SUNDRY NOTICES AND REPORTS ON WELLS
Do not use this form for proposals to drill or to re-enter an abandoned well. Use Form 3160-3 (APD) for such proposals.

8. Well Name and No.
Rose Federal #17

9. API Well No.
30-005-63405

**Rose Federal 17
30-005-63405
Vanguard Operating, LLC
February 25, 2019
Conditions of Approval**

AFTER P&A

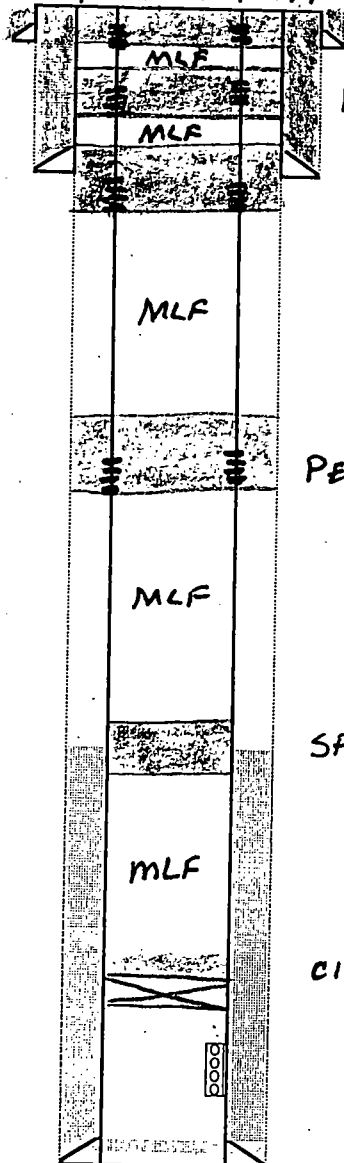
- 1. Operator shall place CIBP at 3685' (50'-100' above top most perf) and place 25 sx of Class C cement on top to seal the Abo Formation. WOC and TAG.**
- 2. Operator shall place a Class C cement plug from 3,100'-2,900' as proposed.**
- 3. Operator shall perf and squeeze at 1525'. Operator shall place a Class C cement plug from 1,525'-1,400' as proposed to seal the Glorietta Formation. WOC and TAG.**
- 4. Operator shall perf and squeeze at 955'. Operator shall place a Class C cement plug from 955'-855'' as proposed to seal the 8-5/8'' shoe. WOC and TAG.**
- 5. Operator shall perf and squeeze at 610'. Operator shall place a Class C cement plug 610'-510' as proposed. WOC and TAG.**
- 6. Operator shall perf and squeeze at 100'. Operator shall place a Class C cement plug from 100' to surface as proposed.**
- 7. See Attached for general plugging stipulations.**
